## Product Change Notice (PCN)

PCN Number: **PCN-0451141R-01**

Product(s) Affected: PJ-035D

DESCRIPTION OF MECHANICAL AND MATERIAL DIFFERENCES AS COMPARED TO PREVIOUS CUI DEVICES

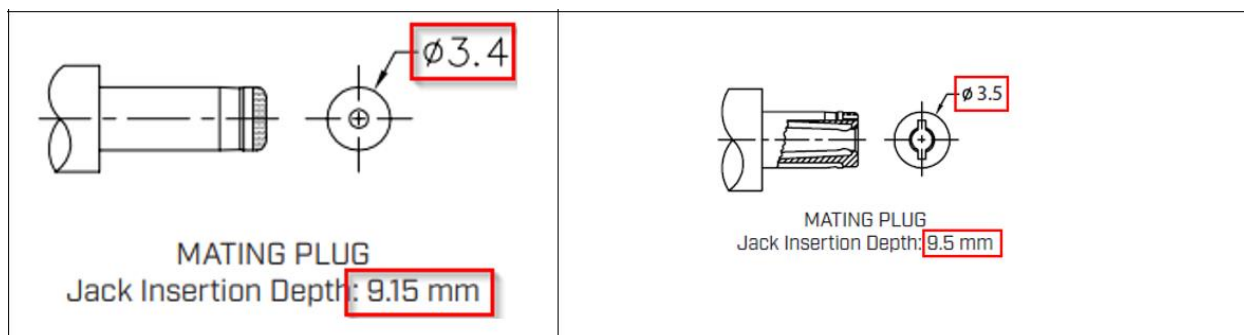
Description of Change: mechanical, and material differences as shown below:

MATERIAL	PLATING
center pin	<b>copper</b>	nickel
terminal 1	brass	tin
terminal 2	<b>copper alloy</b>	tin
terminal 3	brass	tin
plastic	PBT

DESCRIPTION	MATERIAL	PLATING/COLOR
center pin	<b>brass</b>	nickel
terminal 1	brass	tin
terminal 2	<b>bronze</b>	tin
terminal 3	brass	tin
cover	PBT (UL94V-0)	black
housing	PBT (UL94V-0)	black
